**SAS** Sierra Automated Systems  
 RUBICON OUTLINE DRAWING,  
 32 MODULE FRAME WITH 4 METER POD  
 SHEET 1 OF 1  
 DRUBI324DL

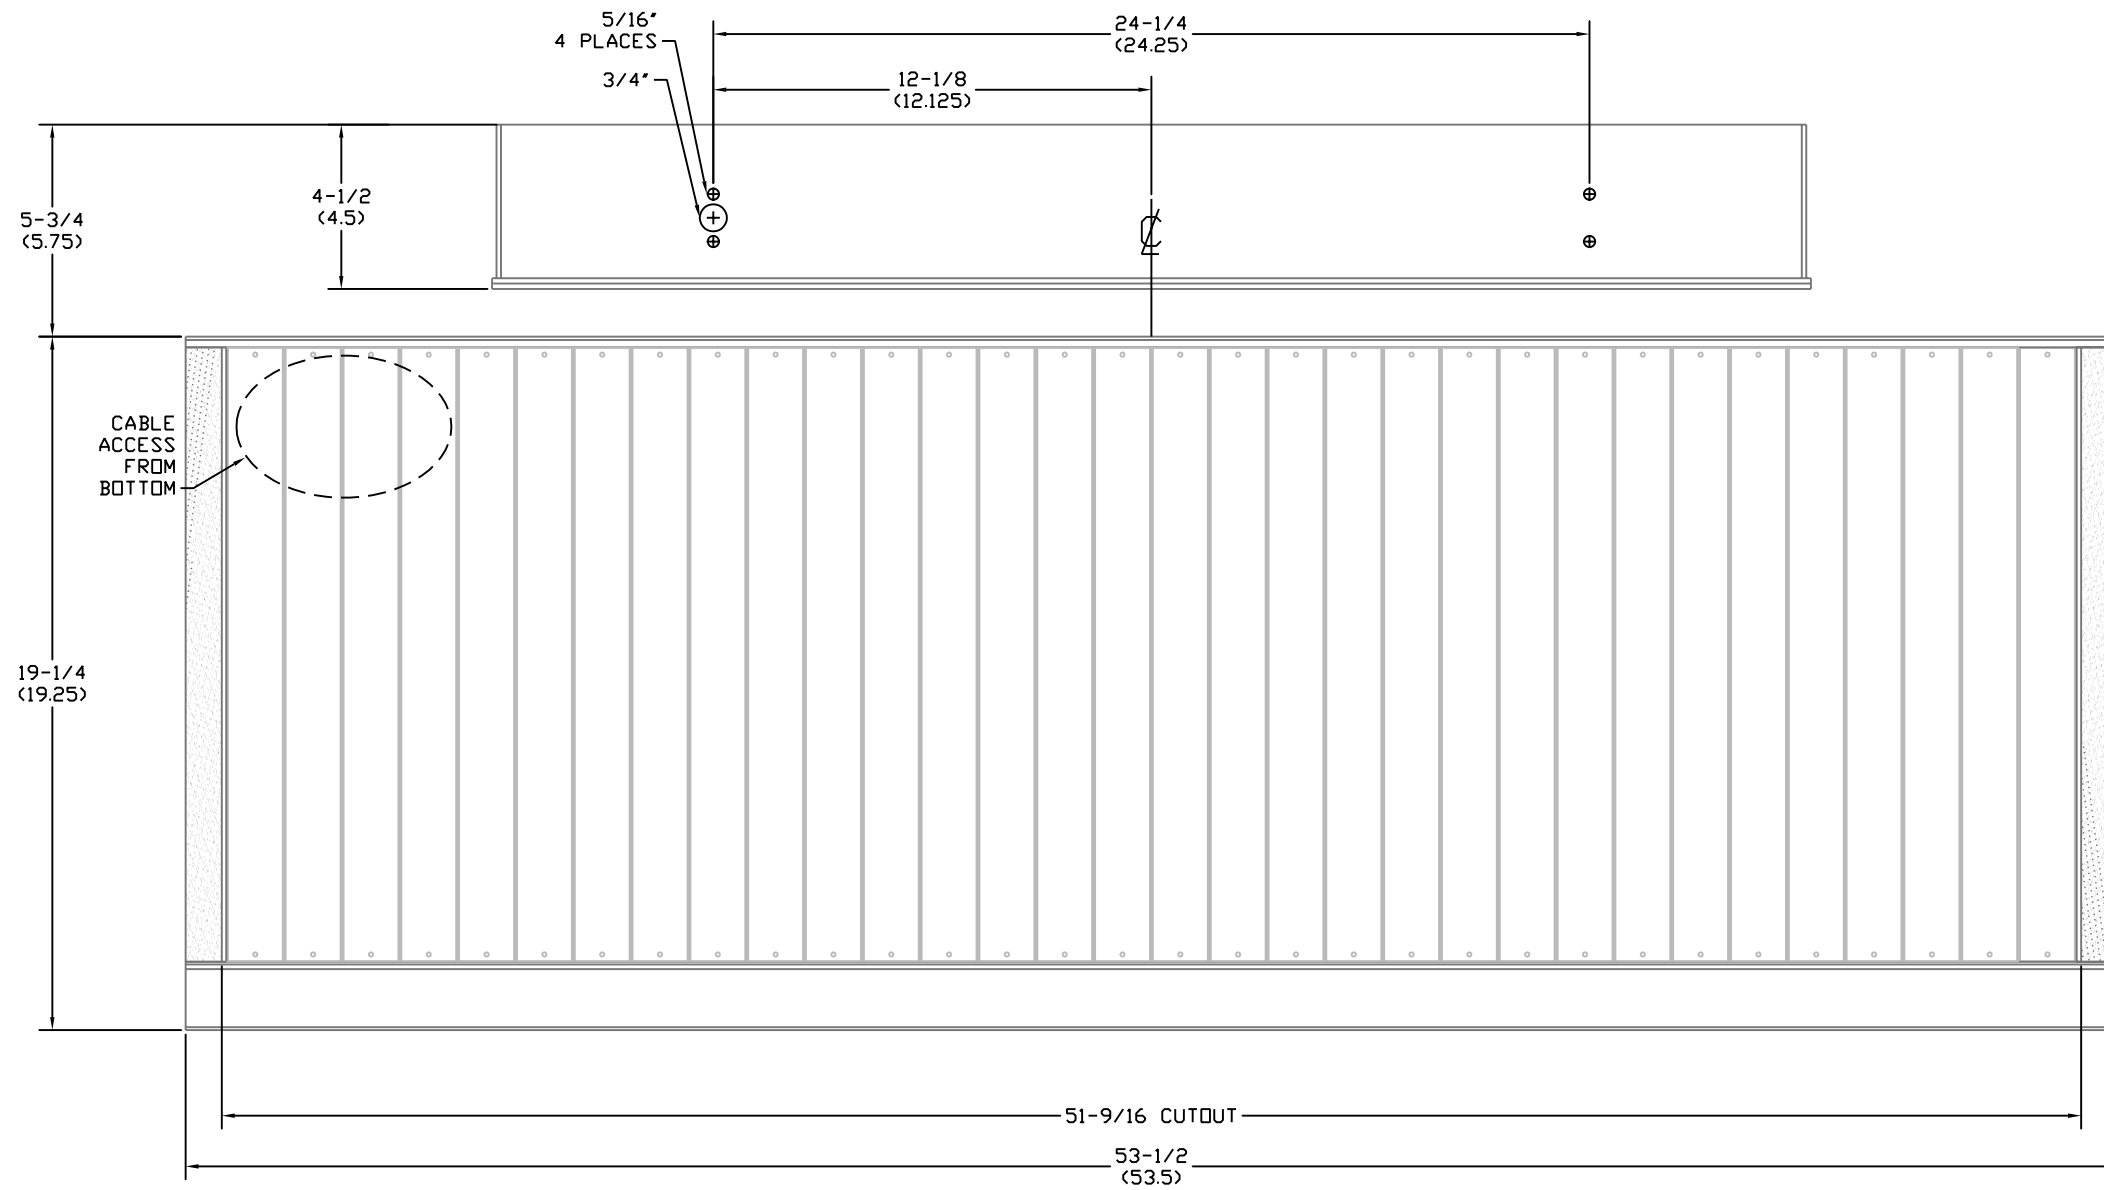
REVISIONS	
DATE	DESCRIPTION
05/17/04	REV B: CHANGED 19-1/5 TO 19-1/4. ADDED 5° DIM. ADDED POWER & CAT5 LOCATION
